Subject: DRAFT Response to U.S. EPR Design Certification Application RAI No. 430, FSARCh. 10, Question 10.02-9
Sent Date: 6/30/2011 8:39:55 AM
Received Date: 6/30/2011 8:39:59 AM
From: WILLIFORD Dennis (AREVA)

Request for Additional Information No. 430

U.S. EPR Standard Design Certification

SRP Section: 10.02 - Turbine Generator

Figure 10.02-9-1—Control Fluid Drain Headers

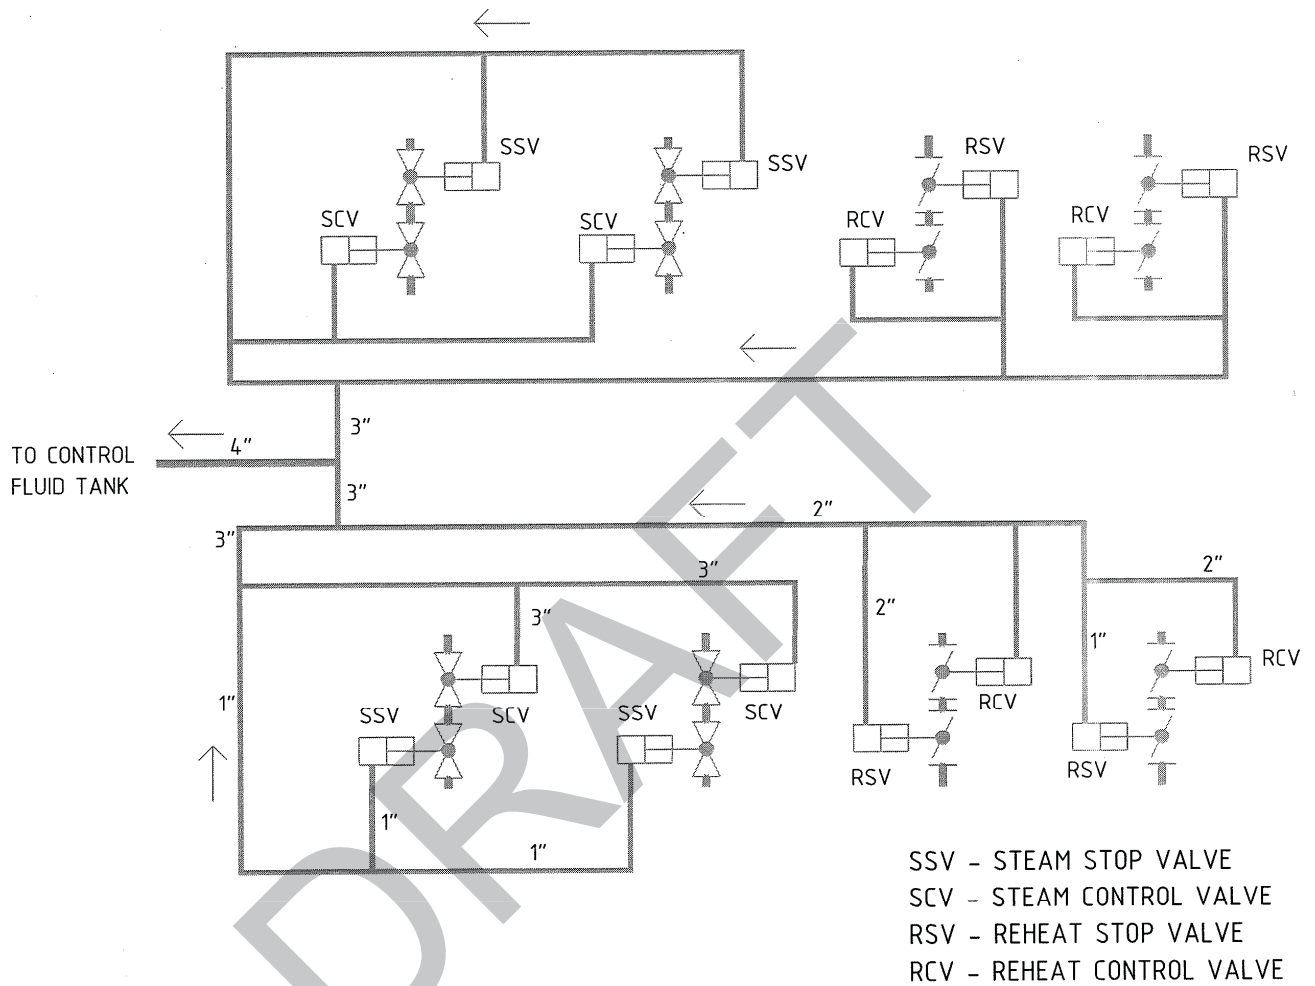
- 1) The description of the turbine overspeed protection systems (including air and hydraulic systems/interfaces as applicable) need to clearly indicate the parts that are shared between the primary and backup systems. For example, shared air and hydraulic dump lines and components such as dump valves and reservoirs need to be described in the FSAR. For clarity, the response should include schematic diagrams that show these flow paths, applicable components, and valves being actuated.

The control fluid system includes one control fluid reservoir with two 100 percent capacity pumps, two 100 percent capacity 25 micron filters, associated valves and instrumentation, regeneration system and control fluid cooling system. The system provides high pressure hydraulic fluid to open the main steam and reheat stop and control valves. Stainless steel piping is used to supply hydraulic fluid to the valve actuators. Connections at the actuator are made with a flexible hose to protect the pipe from vibration. Control fluid from the valve actuators is collected in two stainless steel drain headers, one on each side of the turbine. These drain headers combine into one common drain header, which is sloped back to the control fluid reservoir. The drain headers are sized to handle the maximum control fluid flow requirements maintaining the required valve stroke times. See Figure 10.02-9-1 for a schematic of the control fluid drain lines.

When a trip signal is caused by the overspeed protection system or by any other trip signals, the control fluid is rapidly discharged to the drain manifold. The fluid pressure quickly reduces to atmospheric pressure enabling the spring to close the valves. The fluid returns to the control fluid tank by gravity through the drain headers.

The sizing of the return lines, the materials of construction of the system and the continuous filtration of the control fluid minimizes the potential for blockage of the return lines. Periodic testing of the turbine valves confirms that the return lines are not plugged. Daily testing of the primary and backup overspeed protection systems, including the trip block, confirms that the valves of the trip block are functional. Testing and inspections of turbine components is described in U.S. EPR FSAR Tier 2, Section 10.2.2.12.
